**WELCOME
2019
CATOOSA COUNTY
CONTRACTORS
MEETING**

July 25, 2019

MANDATORY CODES AS OF JANUARY 01, 2020 (ADOPTED WITH GEORGIA AMENDMENTS)

FIGURE R507.5.1(1)
DECK BEAM TO DECK POST

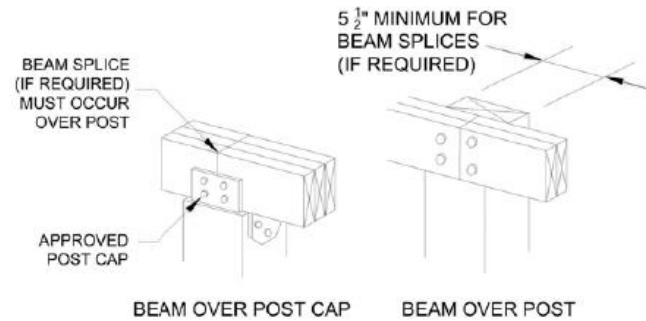
* Revise Figure R507.5.1(1) 'DECK BEAM TO DECK POST' to include a new illustration for "Corner Beam Over Post" as follows:

FIGURE R507.9.1.3(2)
PLACEMENT LAG SCREWS AND BOLTS IN BAND JOISTS
(Effective January 1, 2020)

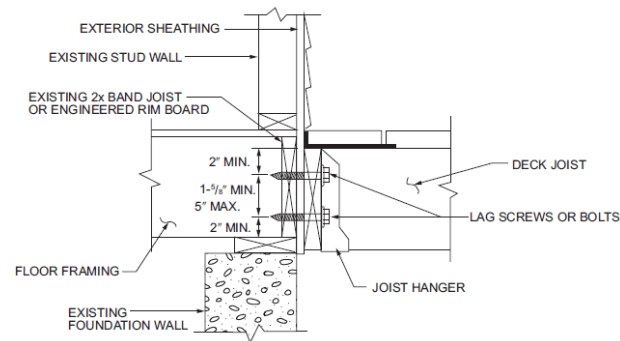
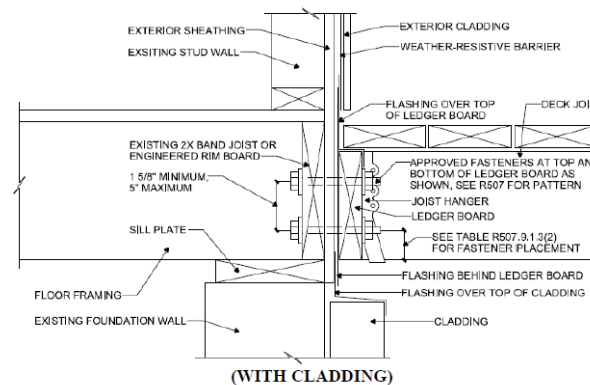
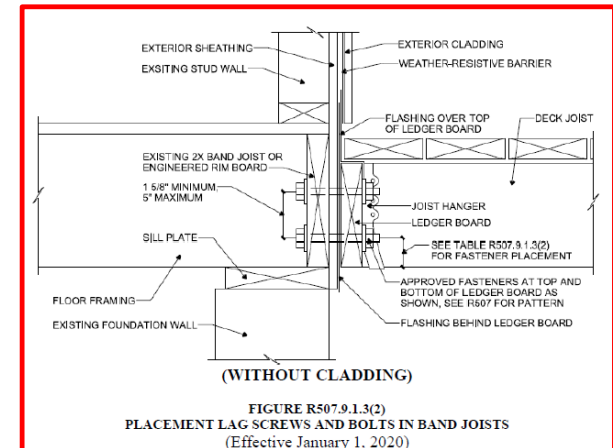
*Revise Figure R507.9.1.3 (2) 'Placement of Lag Screws and Bolts in Band Joists' as follows:

FIGURE R507.9.2(1)
DECK ATTACHMENT FOR LATERAL LOADS
(Effective January 1, 2020)

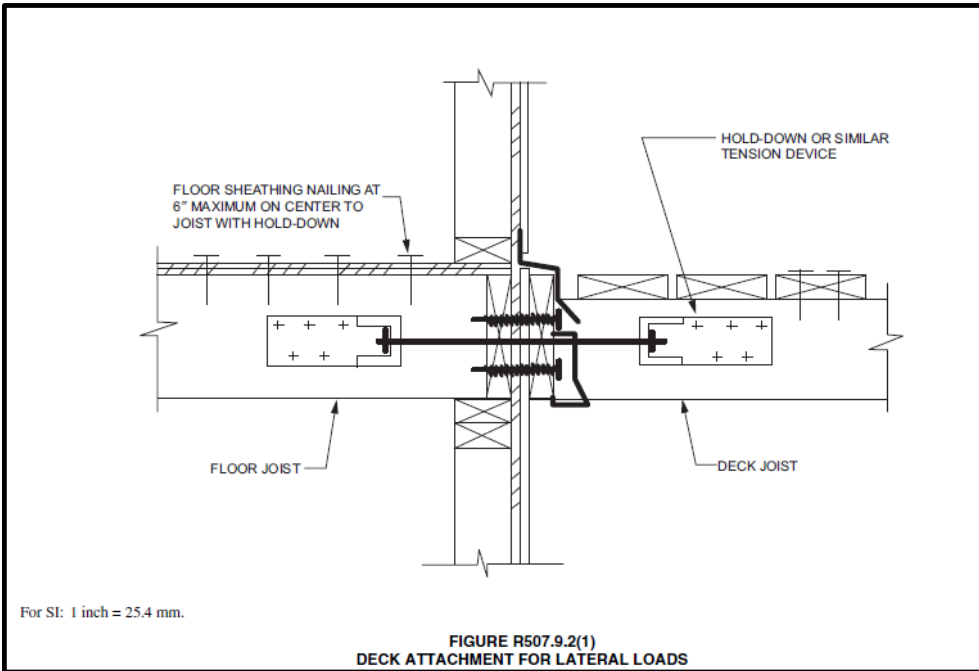
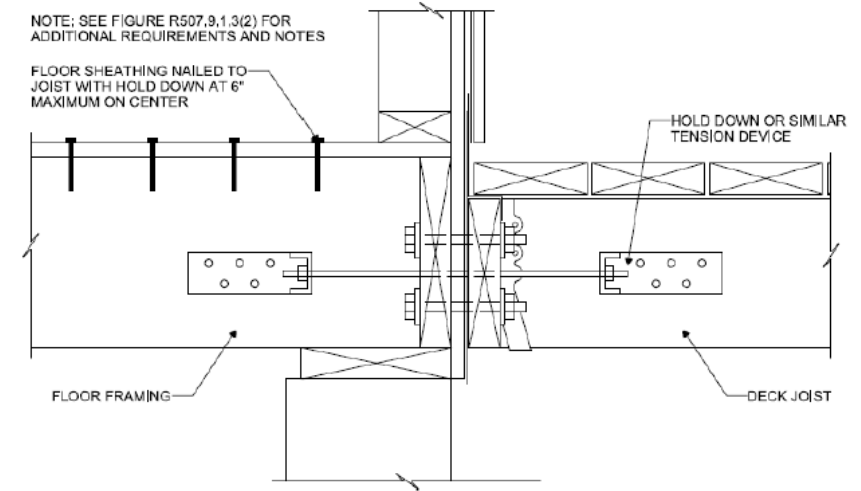
* Revise Figure R507.9.2(1) 'Deck Attachment for Lateral Loads' as follows:

FIGURE R507.9.2(2)
DECK ATTACHMENT FOR LATERAL LOADS
(Effective January 1, 2020)

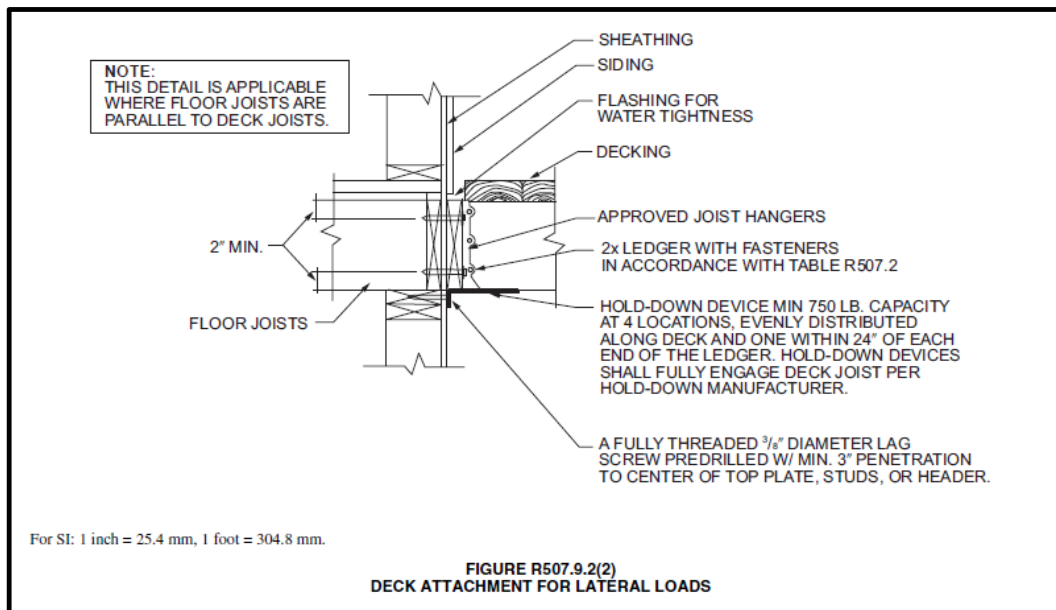
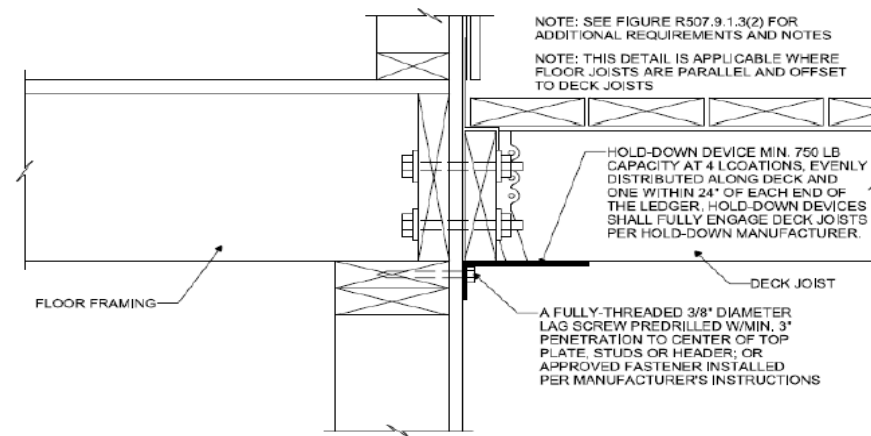
*Revise Figure R507.9.2(2) 'Deck Attachment for Lateral Loads' and as follows:
